Office Action Summary

10/564,983

NAGATA, MASAKAZU

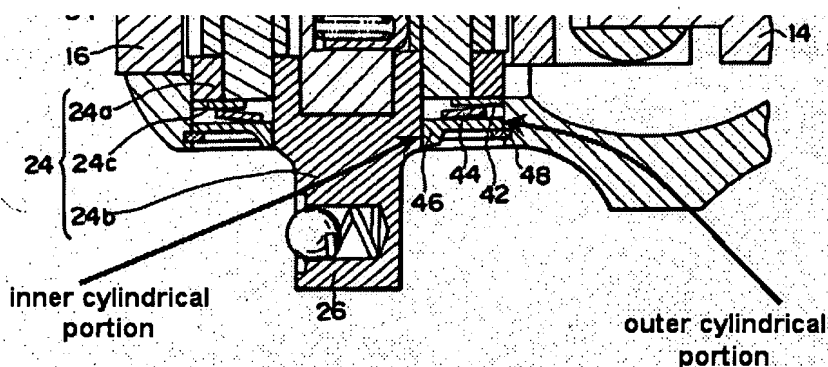
1. Figures 12-15 should be designated by a legend such as --Prior Art-- because only that which is old is illustrated. See MPEP § 608.02(g). Corrected drawings in compliance with 37 CFR 1.121(d) are required in reply to the Office action to avoid abandonment of the application. The replacement sheet(s) should be labeled "Replacement Sheet" in the page header (as per 37 CFR 1.84(c)) so as not to obstruct any portion of the drawing figures. If the changes are not accepted by the examiner, the applicant will be notified and informed of any required corrective action in the next Office action. The objection to the drawings will not be held in abeyance.
2. Claims 1-21 are rejected under 35 U.S.C. 112, second paragraph, as being indefinite for failing to particularly point out and distinctly claim the subject matter which applicant regards as the invention.

4. Claims 1, 6, 8, 10-12, 16, 18 and 20-21 are rejected under 35 U.S.C. 102(b) as being clearly anticipated by the admitted prior art of Figure 12 of the instant invention.

Figure 12 of the instant invention discloses a spring "44", a guide member "46" protecting the spring, hold means "46, 48", drop-out preventing means or snap-ring "48". The guide member has inner and outer cylindrical portions and the spring is accommodated in the space between the portions.

6. Claims 2-3 and 13 are rejected under 35 U.S.C. 103(a) as being unpatentable over the admitted prior art of Figure 12 of the instant invention in view of Kusama (2003/0150298).

Figure 12 of the instant invention discloses all of the claimed subject matter except for having an abrasion preventing member obstructing contact between the shank the annular hold portion, the member having an annular shape with a hole through which a shank projection is fitted. Kusama discloses an abrasion preventing member "32 and/or 71" obstructing contact between the shank the annular hold portion, the member having an annular shape with a hole through which a shank projection is fitted. It would have been obvious to one having ordinary skill in the art to form the device of Figure 12 of the instant invention with an abrasion preventing member obstructing contact between the shank the annular hold portion, the member having an annular shape with a hole through which a shank projection is fitted to prevent abrasion as taught by Kusama.

7. Claims 2-4, 7, 13-14 and 17 are rejected under 35 U.S.C. 103(a) as being unpatentable over the admitted prior art of Figure 12 of the instant invention in view of Horvath (6490953).

Figure 12 of the instant invention discloses all of the claimed subject matter except for having an abrasion preventing member obstructing contact between the shank the annular hold portion, the member having an annular shape with a hole through which a shank projection is fitted and the member having a rotation preventing means. Horvath discloses an abrasion preventing member "246" obstructing contact

8. Claims 5 and 15 are rejected under 35 U.S.C. 103(a) as being unpatentable over the admitted prior art of Figure 12 of the instant invention in view of Bosque (4699028).

Figure 12 of the instant invention discloses all of the claimed subject matter except for the housing be heat treated. Bosque discloses a tool housing being heat treated. It would have been obvious to one having ordinary skill in the art to form the housing of Figure 12 of the instant invention as heat treated for added strength as taught by Bosque.
